UNITED STATES PATENT AND TRADEMARK OFFICE

10/553,848

Office Action Summary	Application No. 10/553,848	Applicant(s) GOTO ET AL.	
	Examiner MICHAEL BAND	Art Unit 1795

DETAILED ACTION

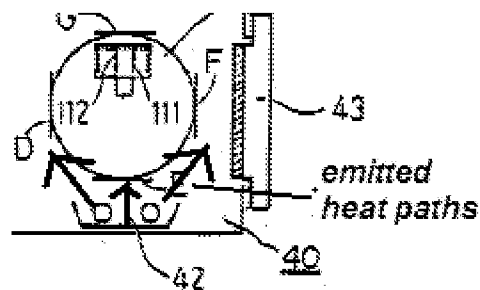
9. On p. 8-9, the Applicant argues that Takahashi et al fails to disclose two or more substrates being in the same vacuum chamber. The Applicant also argues that Takahashi et al fails to disclose a deposition position in which a substrate is heated while being subjected to deposition. The Applicant also argues that Takahashi et al fails

The Examiner respectfully disagrees. Takahashi et al discloses a plurality of wafers (i.e. substrates) are inserted into a cassette [11], where said cassette (i.e. plurality of wafers) [11] is transported to the sputter chamber [40] (col. 19-30; fig. 1), thus a plurality of substrates (i.e. cassette [11]) are simultaneously in the same vacuum chamber (i.e. sputter chamber [40]). With regards to heating the substrates while being subjected to deposition, there is no claim limitation requiring heating the substrate while subjecting said substrate to deposition. However Takahashi et al discloses in fig. 1 a heat lamp [42] heating the substrates at stage F during deposition since there exists no partition between stage E and F to prevent the heat from said heat lamp [42] to stage F. The cropped figure below of fig. 2 serves to further clarify the heat from heat lamp [42] being present in stage F.
